CITY PLAN COMMISSION STAFF REPORT

Bodhi Residential Development

CD-CPC-2021-00100 -Rezoning with a plan

Report Date: October 15, 2021
Case Number: CD-CPC-2021-00100
Project: Bodhi Residential Development

BUILDING ELEVATIONS

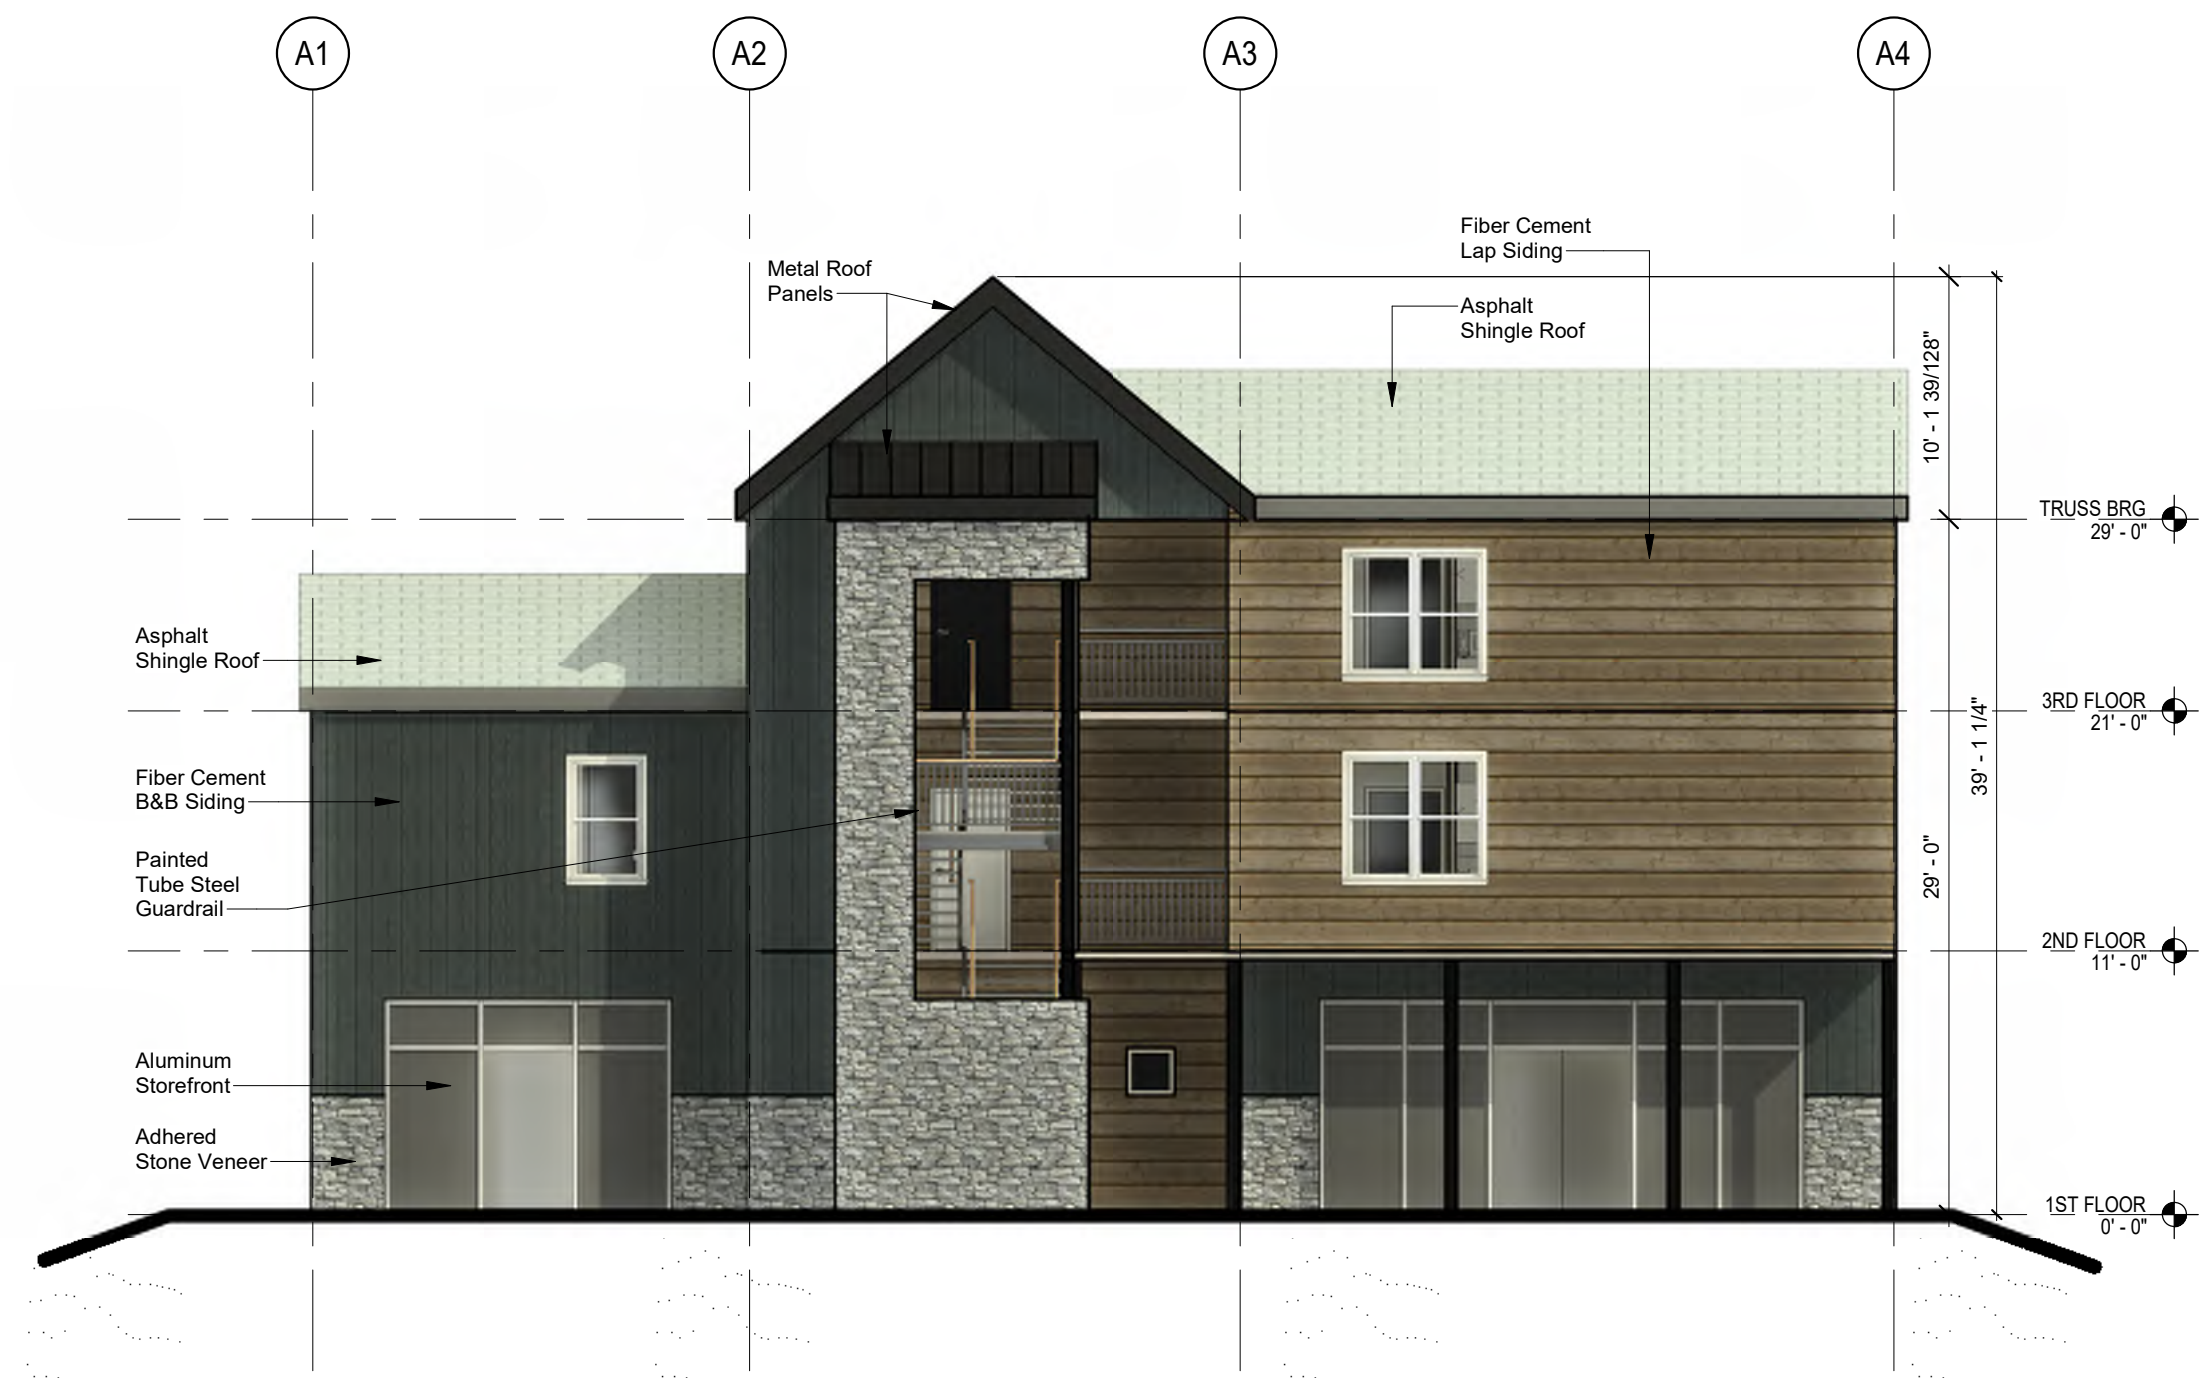
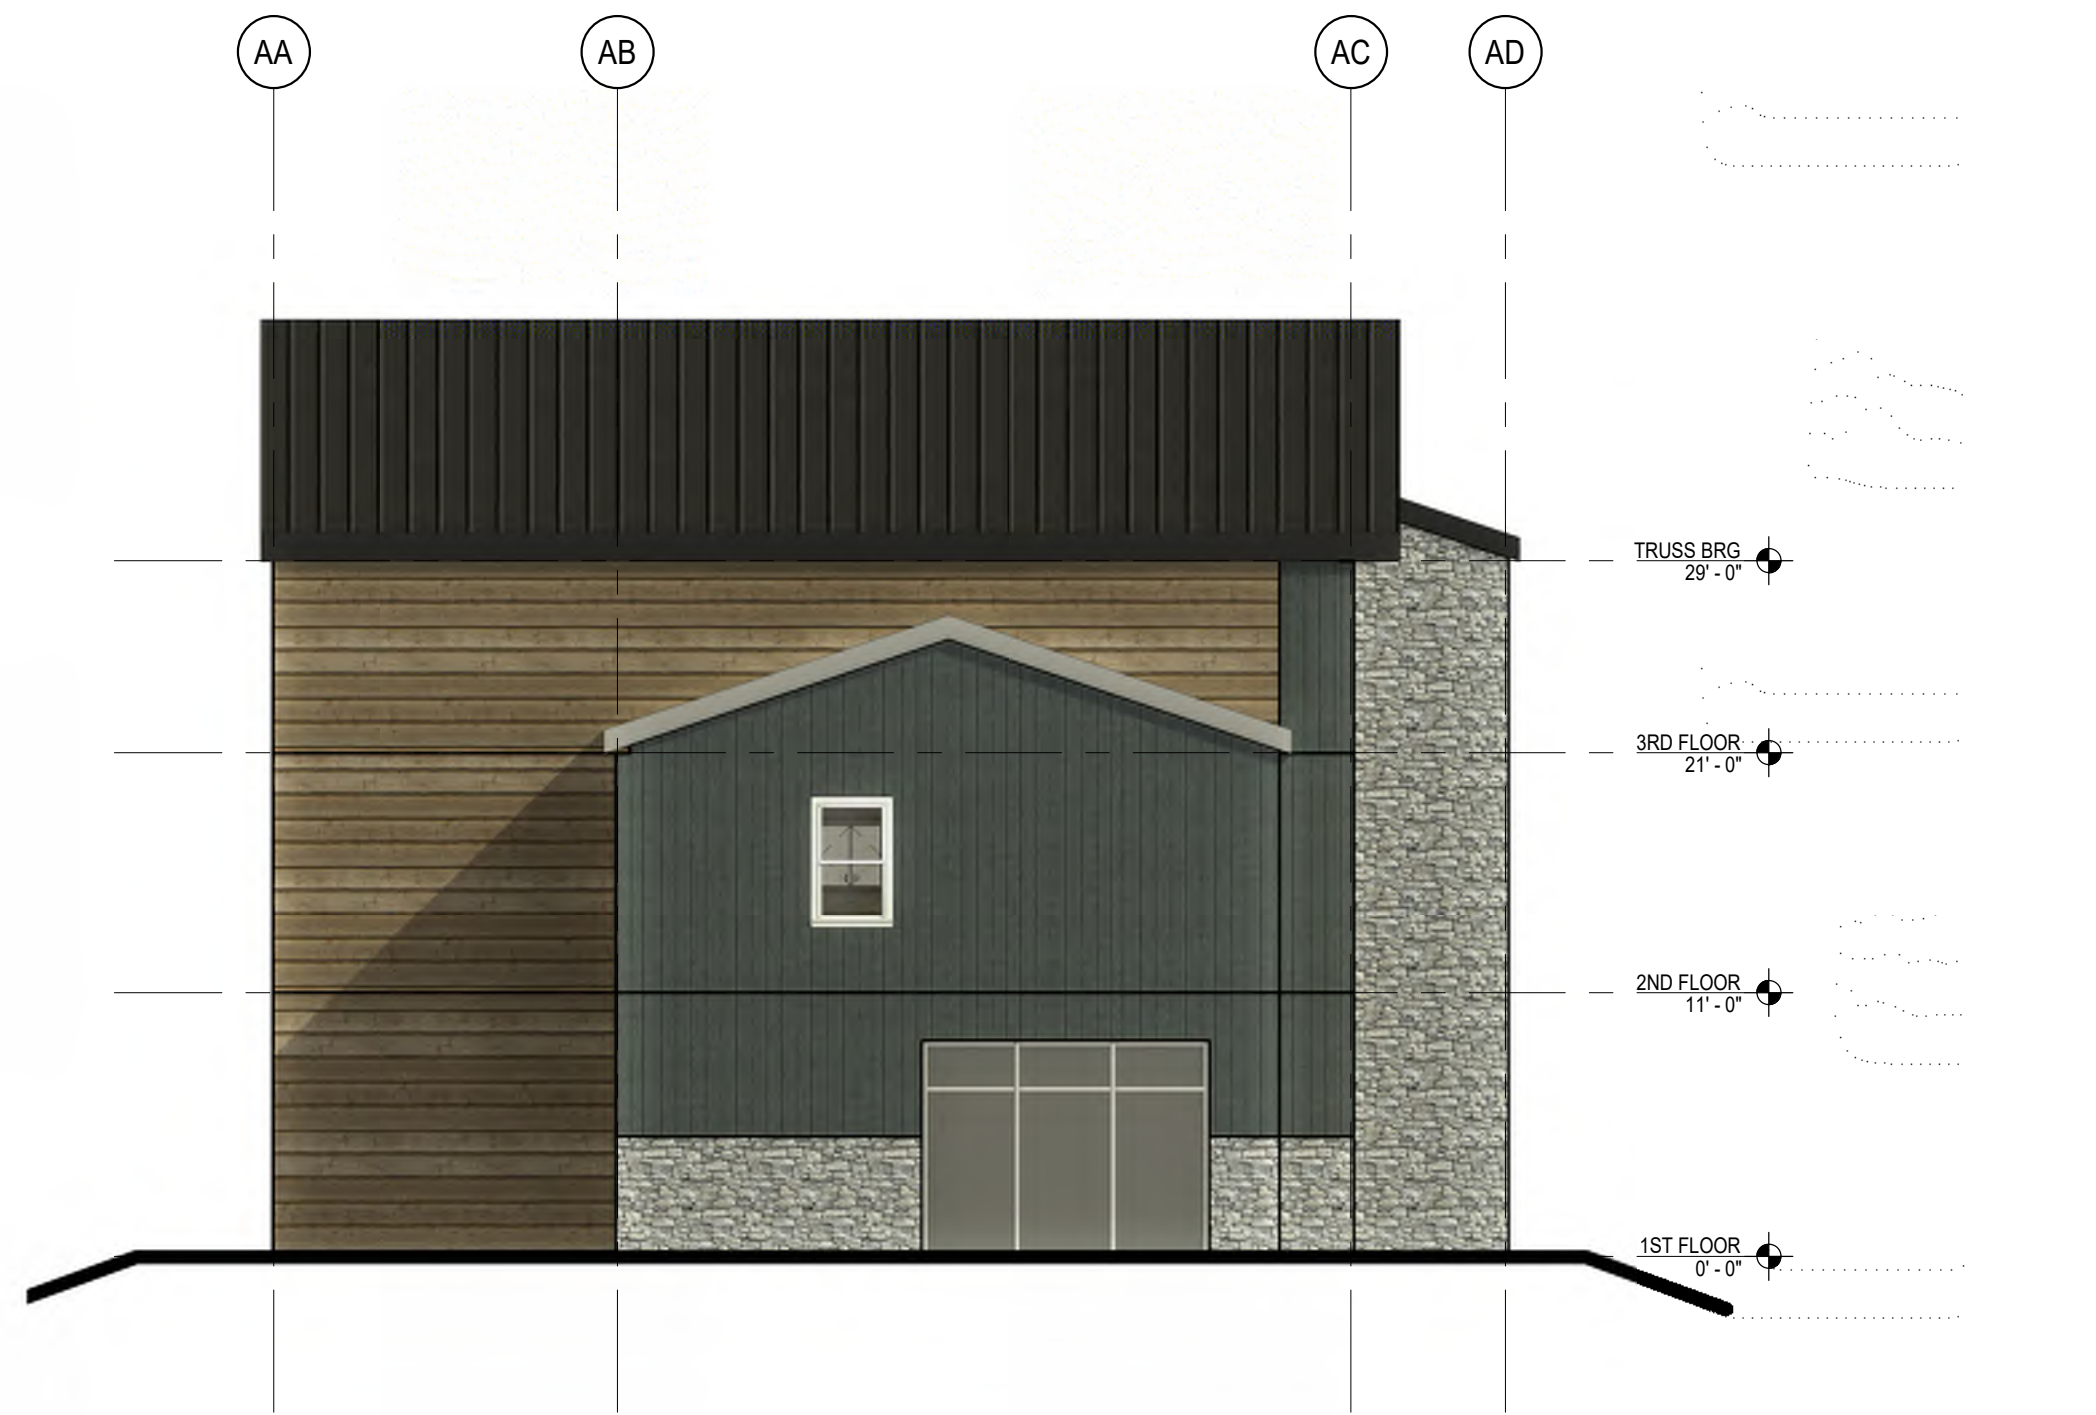
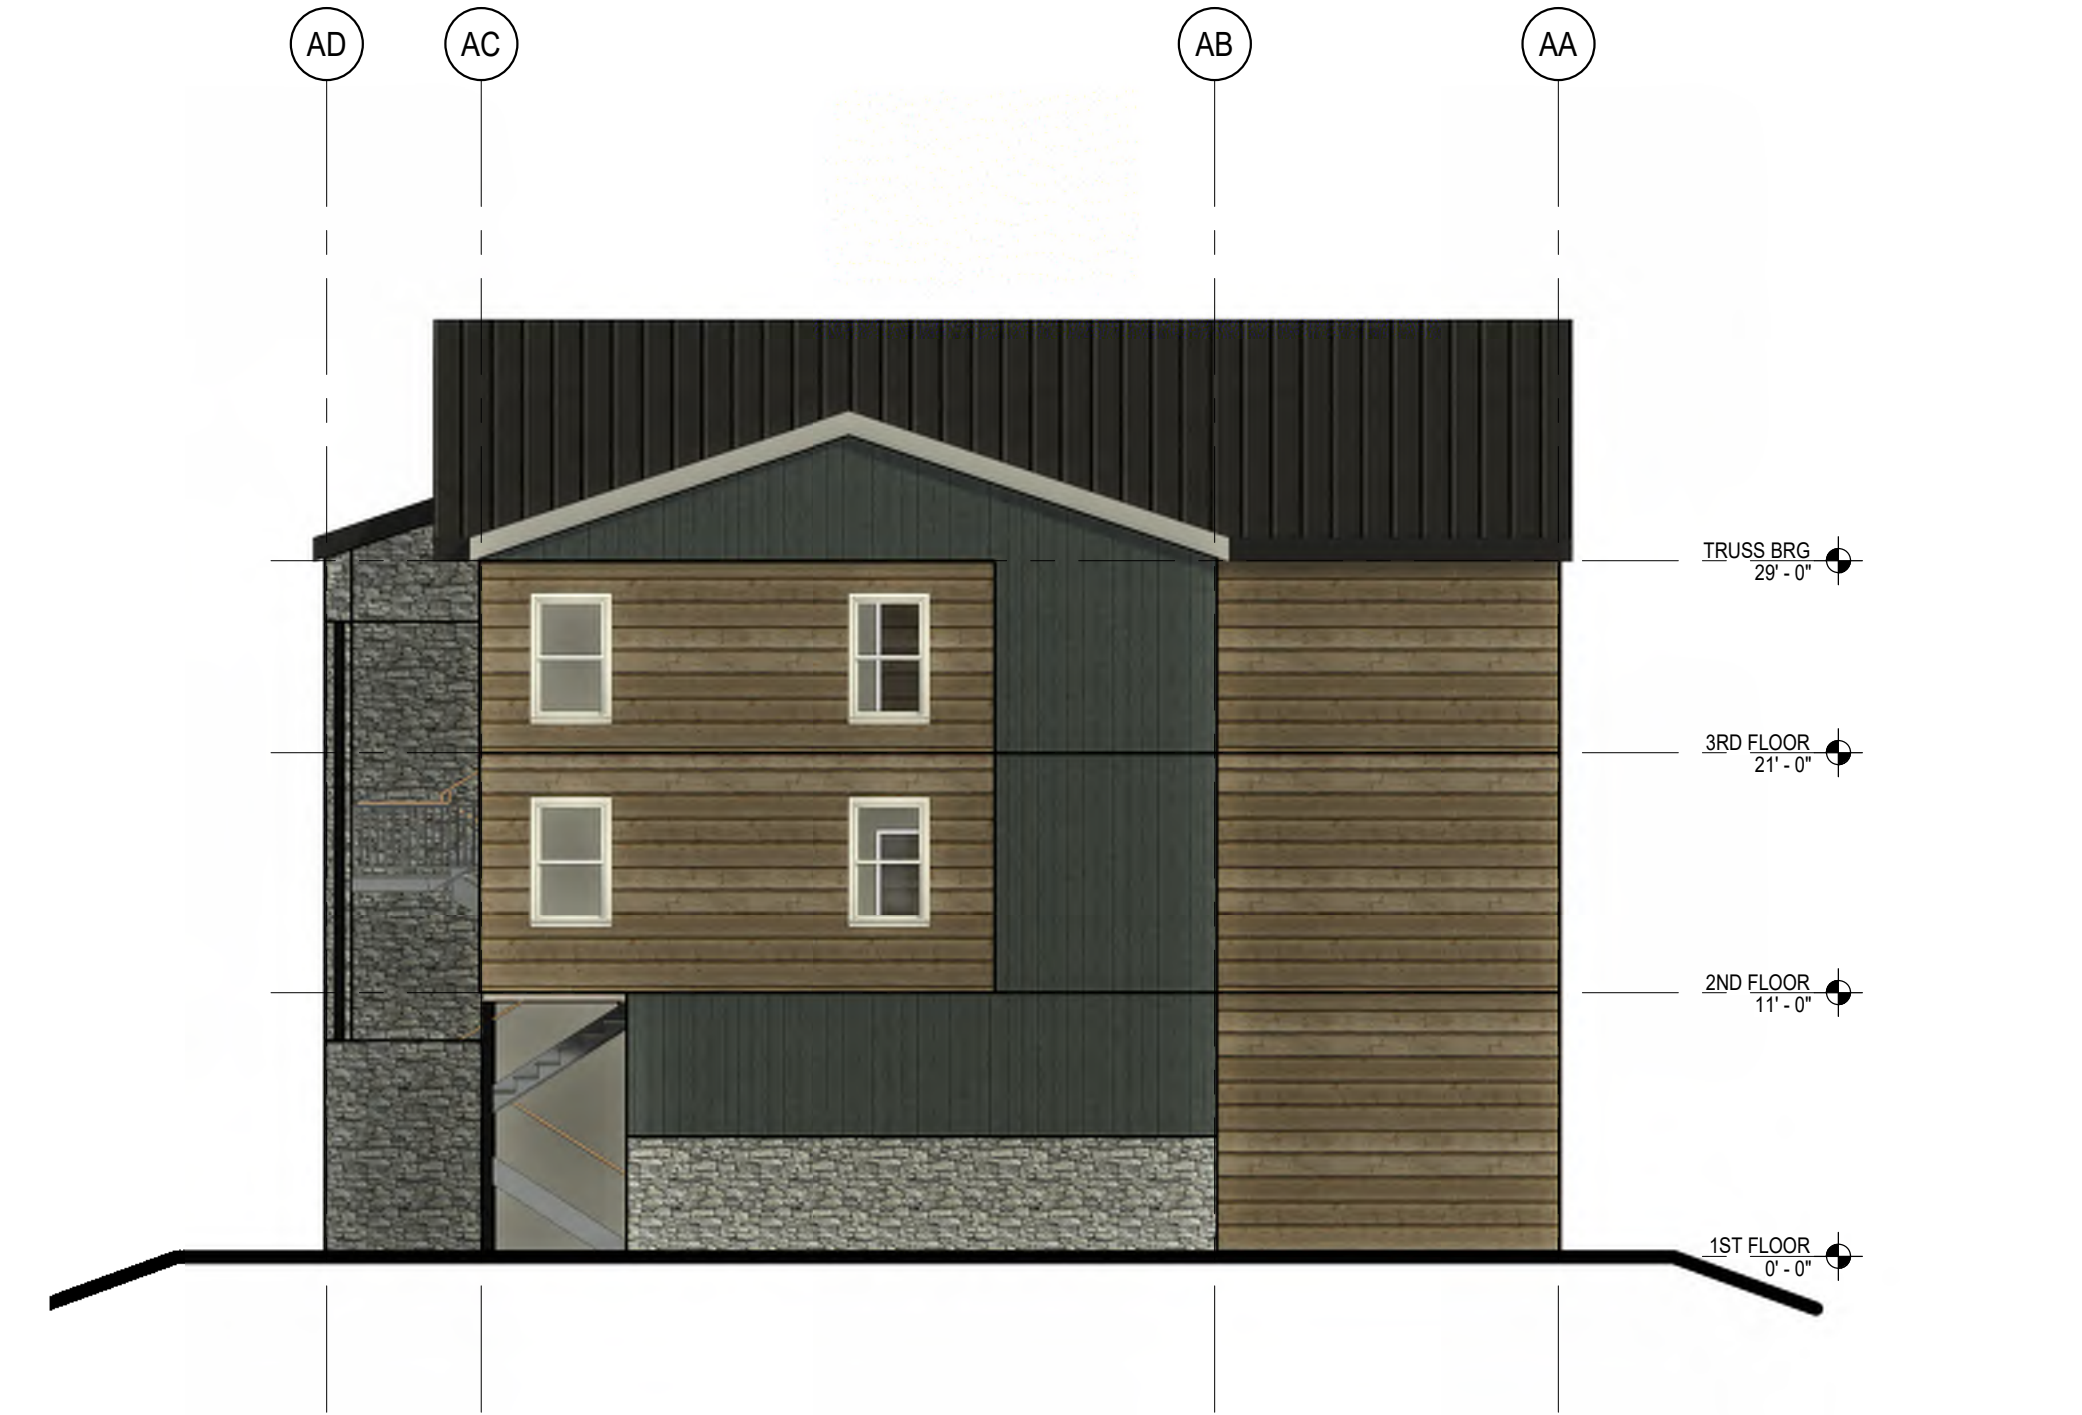
The 3-story apartment buildings are proposed to be primarily fieldstone veneer, horizontal and vertical lapping with asphalt shingles. Staff recommends additional information prior to ordinance request.

5. Show all revision dates on the cover sheet. Revise Plans and Resubmit (10/15/2021)
6. All pertinent information on the building elevation sheet including architect and developer information. Revise Plans and Resubmit (10/15/2021)

18. That the developer provide detailed architectural information on the proposed building for review and approval by staff prior to ordinance request or submit a design guideline for the proposed development. The design guidelines shall call out how this plan incorporates the Heart of the City Area Plan design guidelines wherever the opportunity presents itself. The guidelines shall call out all preferred and prohibited building materials. (10/15/2021)
